Resolution CARPC No. 2013-3

Amending the *Dane County Land Use and Transportation Plan* and *Dane County Water Quality Plan* by Revising the Central Urban Service Area Boundary and Environmental Corridors in the Town of Verona

Map 1 Raymond Rd

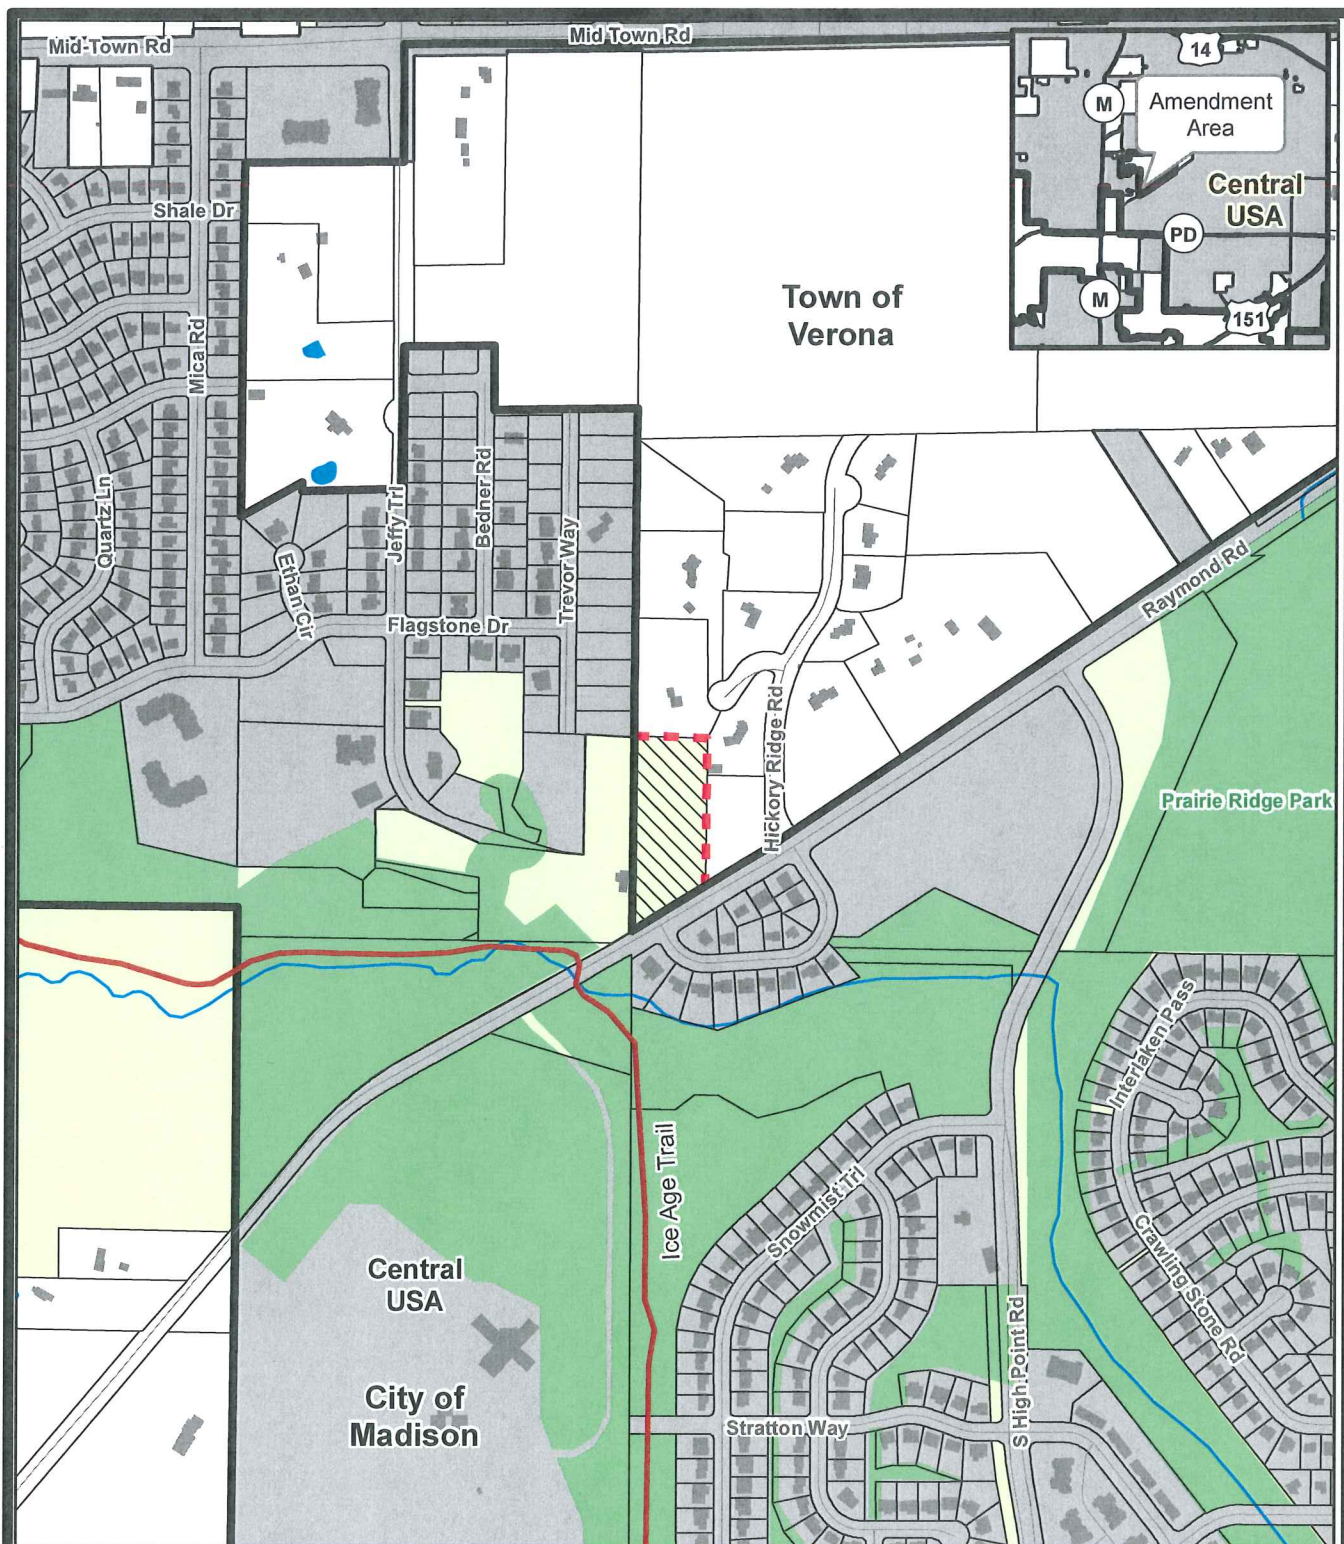
NOW, THEREFORE, BE IT RESOLVED that in accordance with §66.0309, Wis. Stats., and Sec. 208 of Public Law 92-500, the Capital Area Regional Planning Commission amends the *Dane County Land Use and Transportation Plan* and recommends the amendment of the *Dane County Water Quality Plan* by revising the Central Urban Service Area boundary and environmental corridors as shown on the attached map.

1. Submit a detailed stormwater management plan for CARPC and DCL&WCD staff review and approval prior to land disturbing activities in the amendment area. The stormwater management plan for the amendment area should include the following:

2. The City includes a majority of the steep wooded slopes in private open space, as proposed. The City provides stringent site plan review and erosion control inspection for the steep wooded slopes that are not put in open space.
